Pacific Grove Unified School District
435 Hillcrest Avenue, Pacific Grove, CA 93950
Robert Down Elementary School Site Improvements
Notice to Bidders - Addendum 03

Addendum Date: 3/23/2026

AD03-01: Revisions to Project Manual

AD03-02: Pre-Bid Questions and Answers

PROJECT # 25.052
ISSUE DATE: 03/23/2026
SHEET # **A1.11**

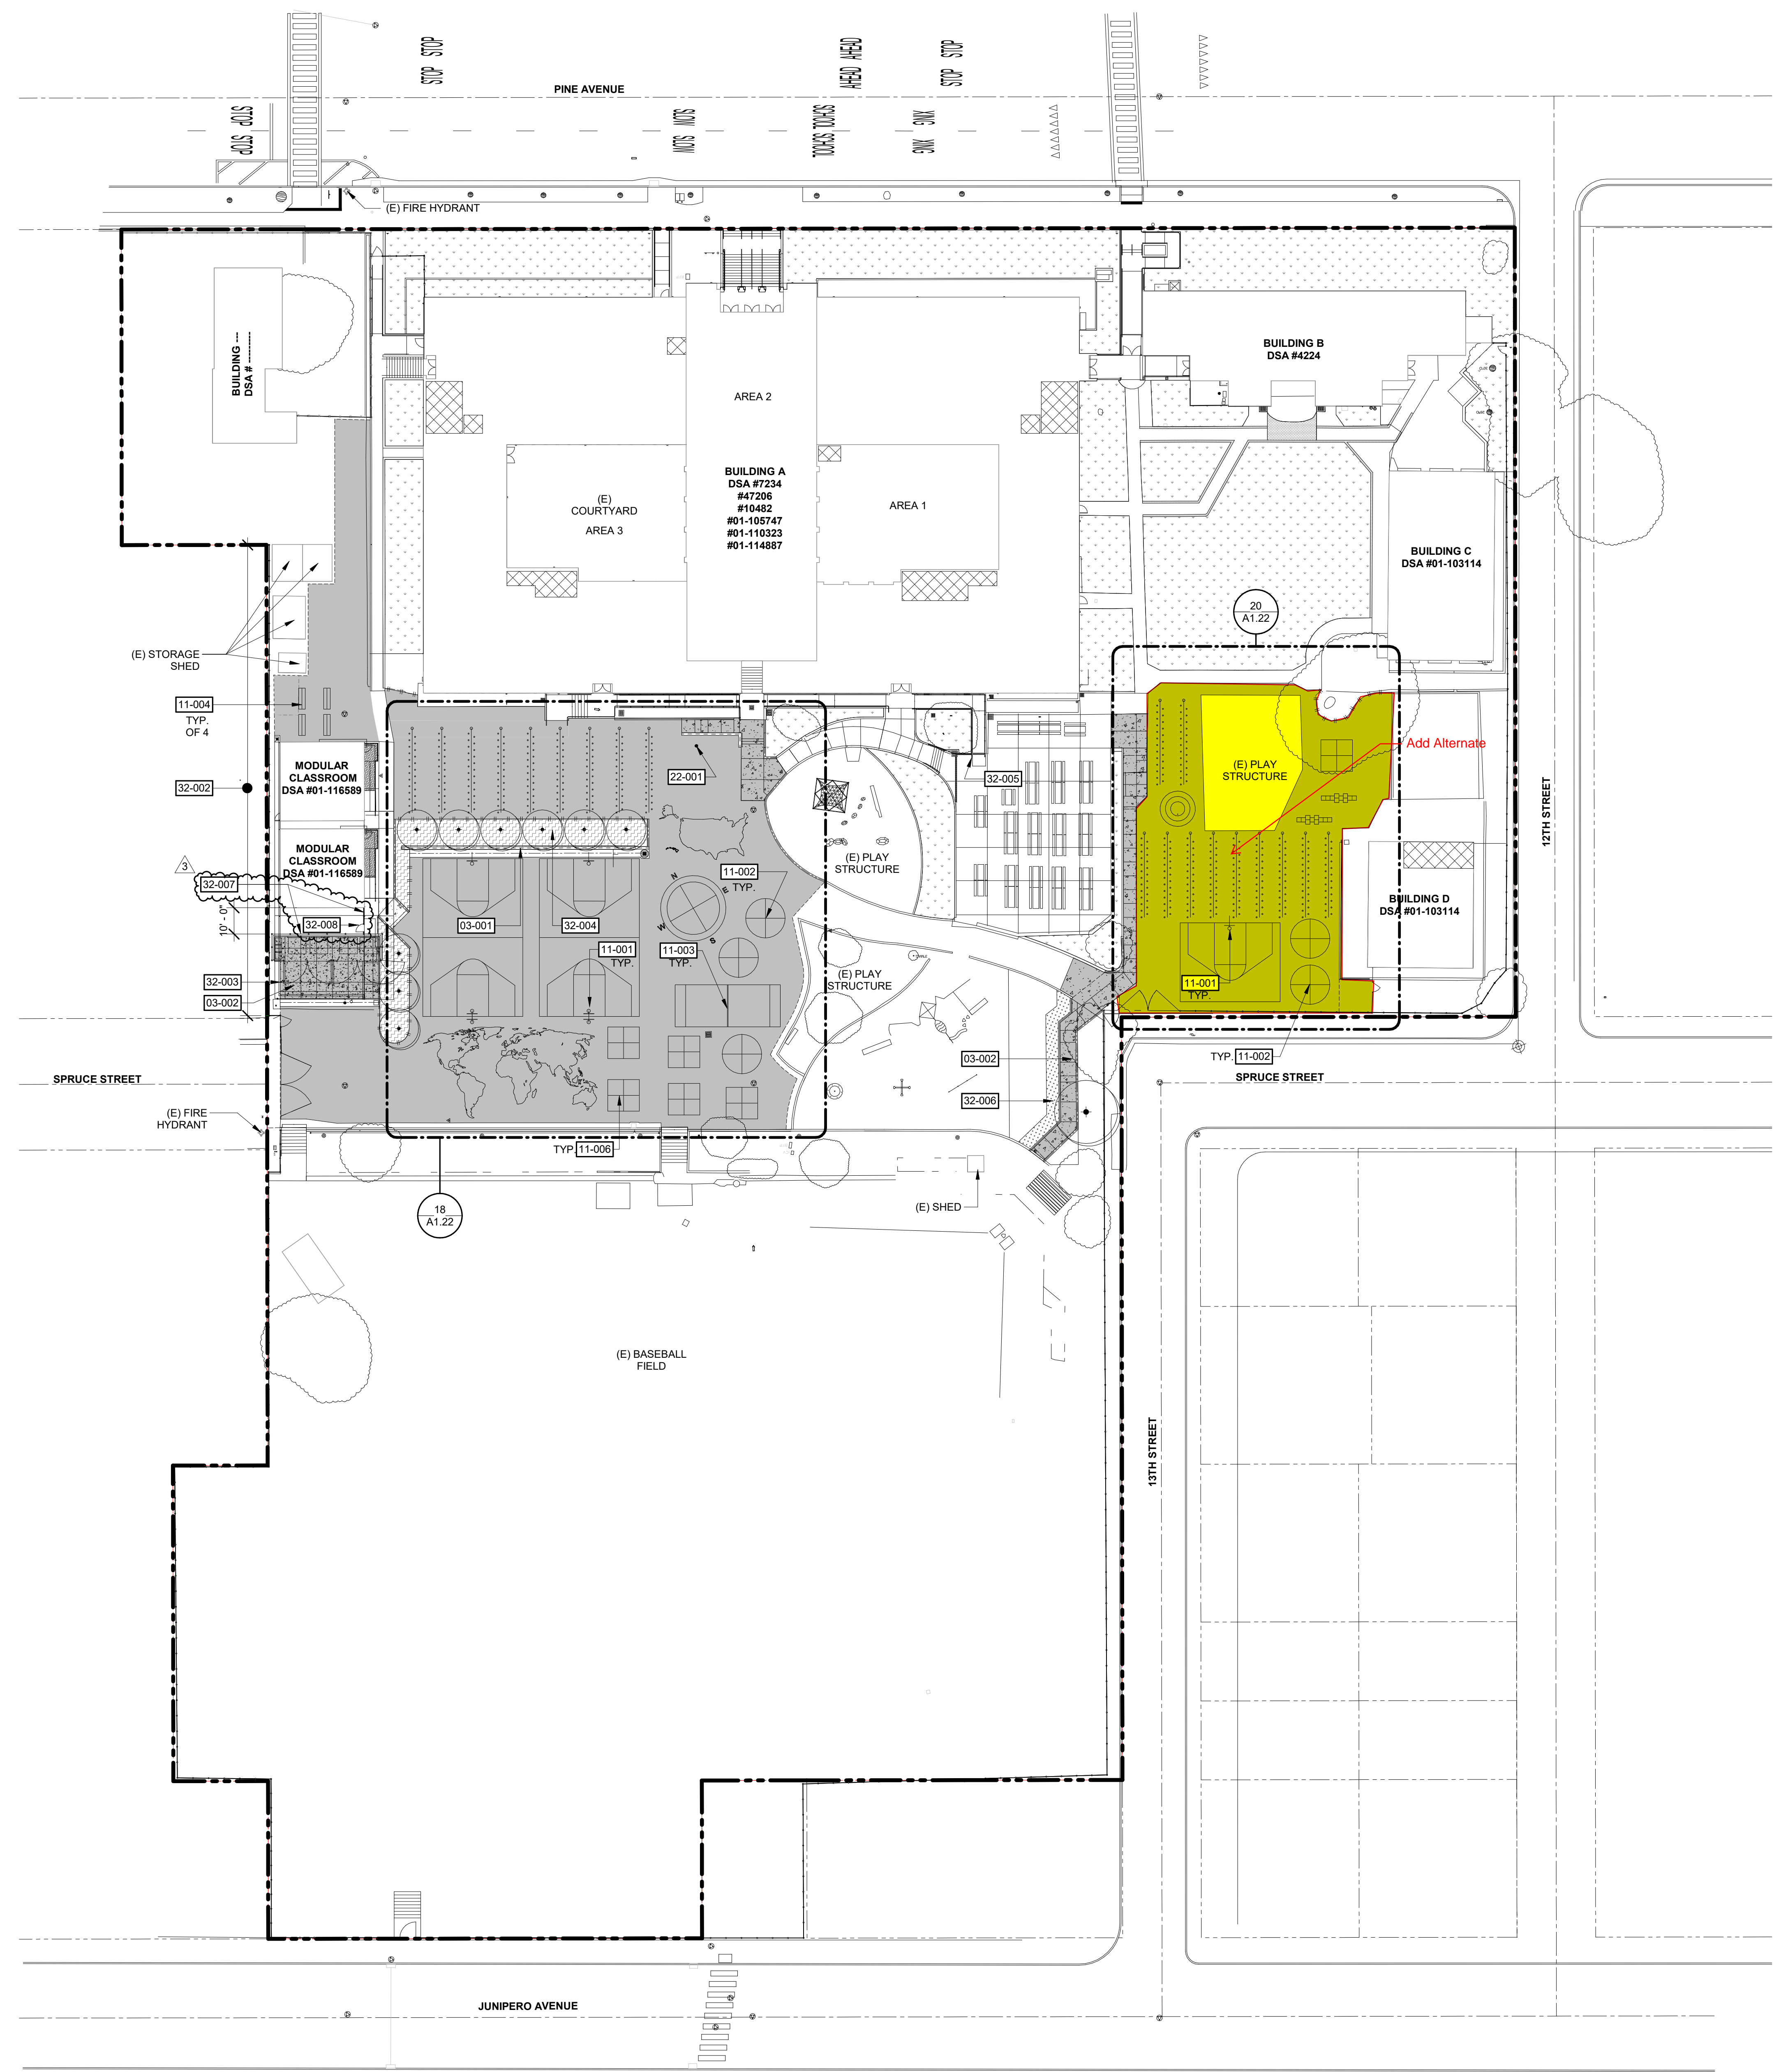
1. Is the concrete walkway, landscape and asphalt ramp next to the East Playground part of the base bid or additive work?
Only asphalt paving shown within the boundary indicated on Addendum 3 revised sheet A1.11 is part of Alternate 1. All other scope is part of the base bid.

ITEM 3D.002 Sheet A1.11 CAMPUS SITE PLAN – Add keynote notation 32-007 at fencing between new trash enclosure and existing Relocatable building at west side of the site. Add KEYNOTE 32-007 to read “CHAIN LINK FENCE, SEE DETAIL 2&3/A1.21.”

- ITEM 3D.003** **Sheet A1.11 CAMPUS SITE PLAN** – Add keynote notation 32-008 at fencing gate between new trash enclosure and existing Relocatable building at west side of the site. Add KEYNOTE 32-008 to read “CHAIN LINK GATE, SEE DETAIL 4/A1.21.”

9 BOTTLE FILLER STATION ELEVATION
SCALE: 1" = 1'-0"

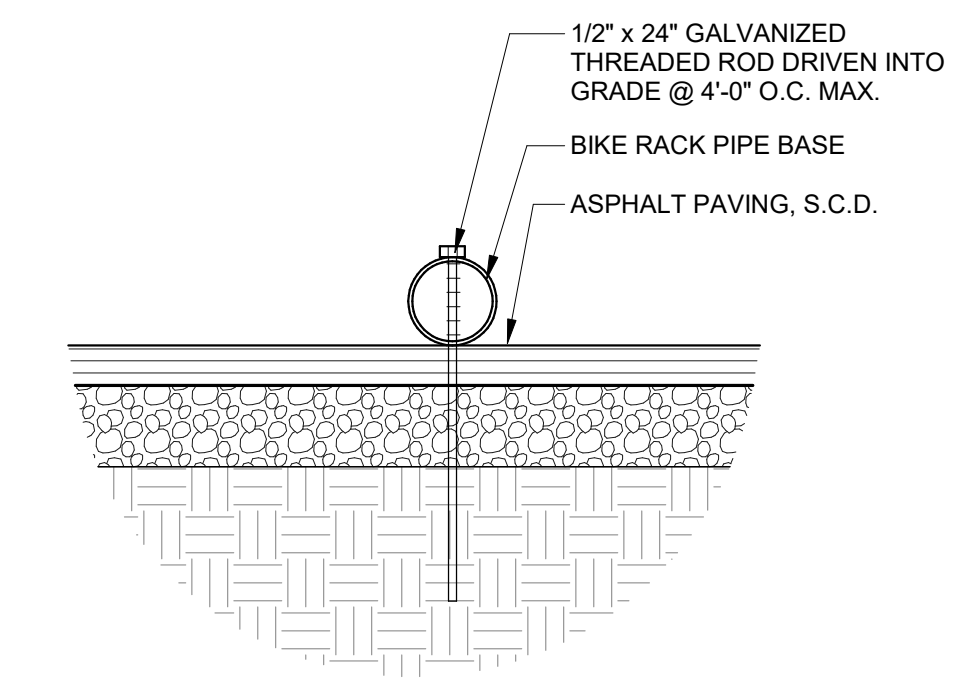
6. Please provide spec for new drinking fountain referenced on sheet C3.1 and connection detail.
Drinking fountain manufacturer, model number, and attachment details are included on sheet A1.21 in Addendum 3 revised drawings.

- ITEM 3D.004** **Sheet A1.21 SITE DETAILS** – Add bottle filling station elevation. See detail 9/A1.21 BOTTLE FILLING STATION ELEVATION.
- ITEM 3D.005** **Sheet A1.21 SITE DETAILS** – Add bottle filling station footing detail. See detail 10/A1.21 BOTTLE FILLING STATION FOOTING.

20 ENLARGED PLAN - TRASH ENCLOSURE
SCALE: 1/4" = 1'-0"

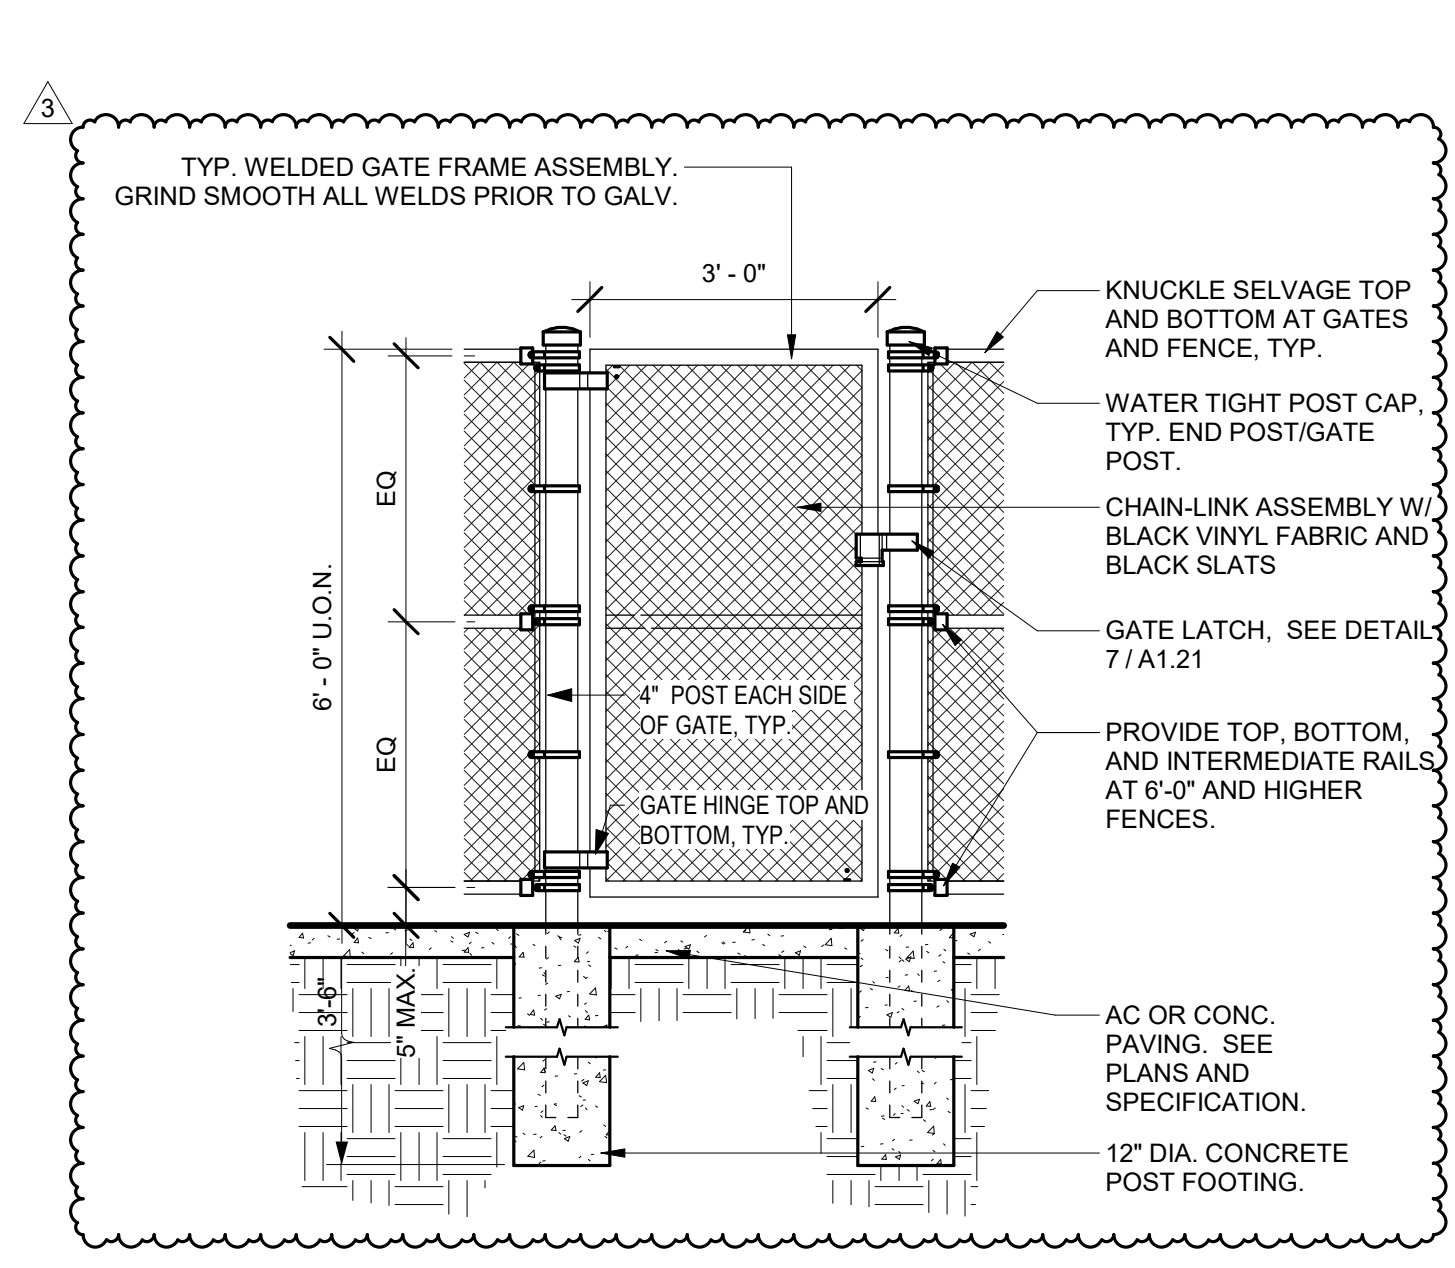
- ITEM 3D.006** **Sheet A1.21 SITE DETAILS** – Add chain link gate detail. See detail 4/A1.21 CHAIN LINK GATE.
- ITEM 3D.007** **Sheet A1.21 SITE DETAILS** – Add curb clarification note to read “6” CONC. CURB, SEE CIVIL DWGS.” See detail 20/A1.21 ENLARGED PLAN – TRASH ENCLOSURE.

18 ENLARGED PLAYGROUND PLAN - WEST
SCALE: 1/16" = 1'-0"

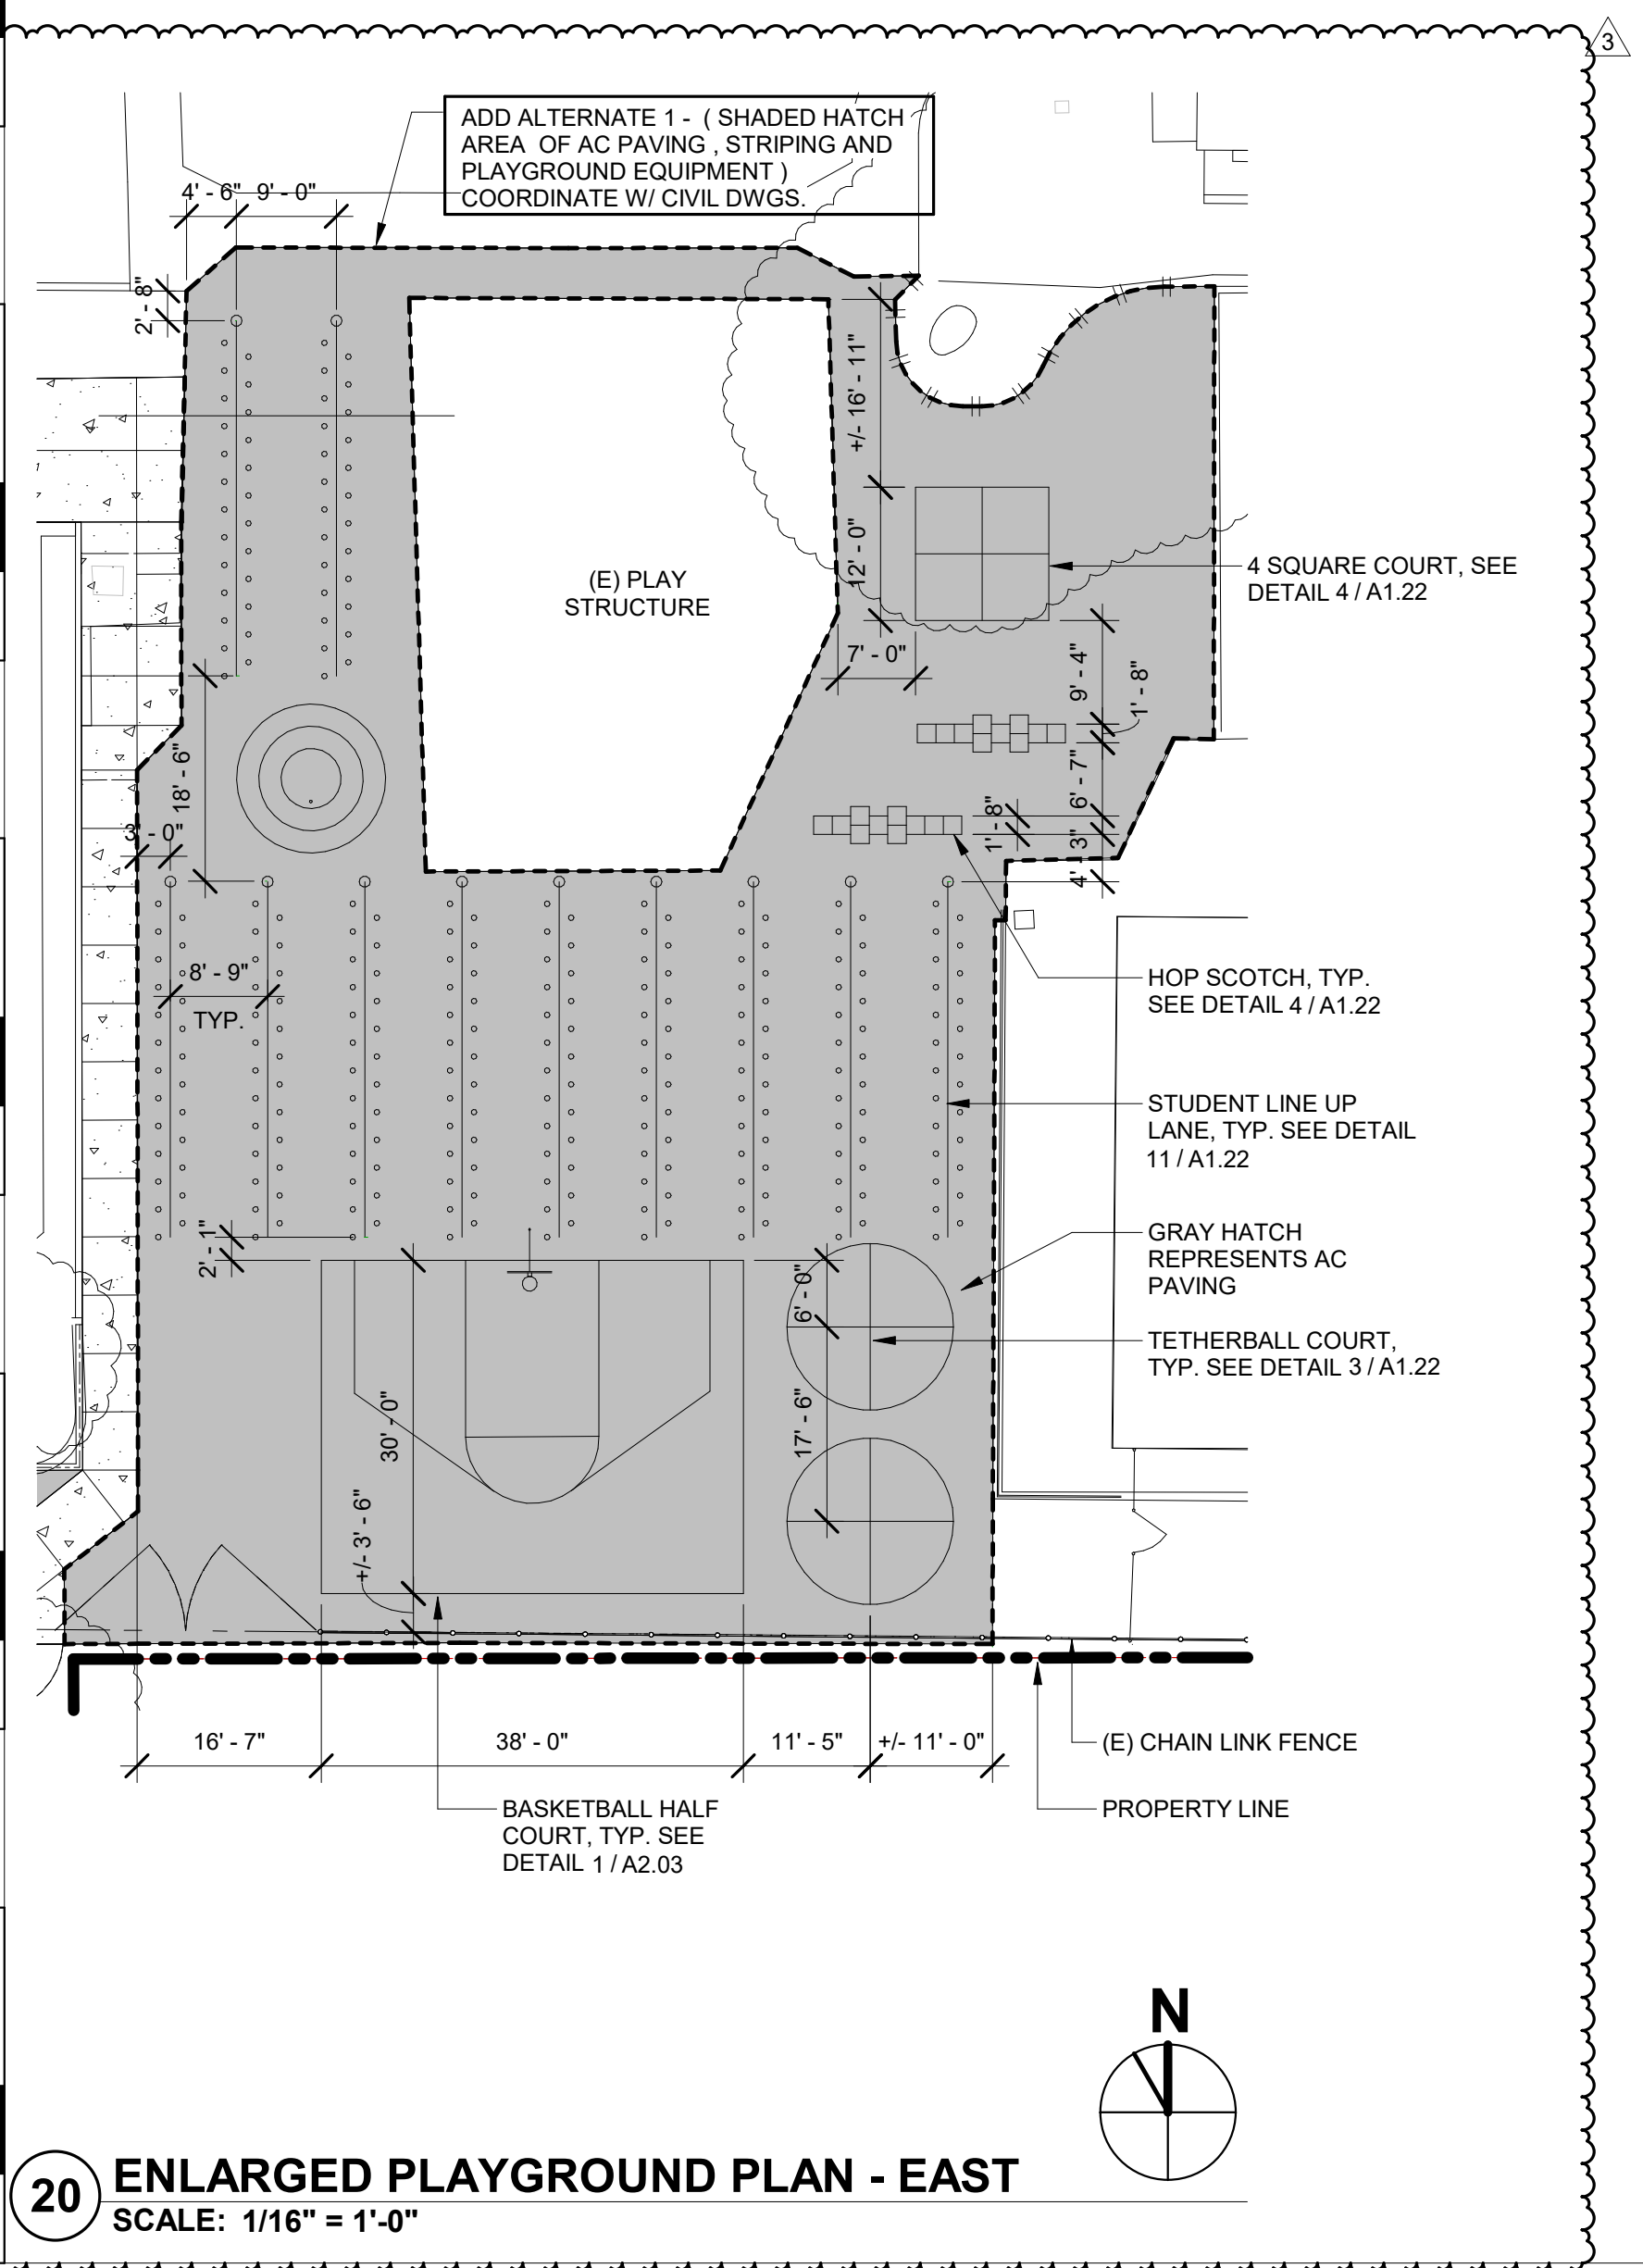
- ITEM 3D.008** **Sheet A1.21 SITE DETAILS** – Delete detail 12/A1.21.
- ITEM 3D.009** **Sheet A1.22 SITE DETAILS** – Clarify dimensions of USA map striping per 18/A1.22 ENLARGED PLAYGROUND PLAN - WEST.

- ITEM 3D.010** **Sheet A1.22 SITE DETAILS** – Clarify dimensions of world map striping per 18/A1.22 ENLARGED PLAYGROUND PLAN - WEST.
- ITEM 3D.011** **Sheet A1.22 SITE DETAILS** – Clarify add alternate limit of work area per 20/A1.22 ENLARGED PLAYGROUND PLAN - EAST.
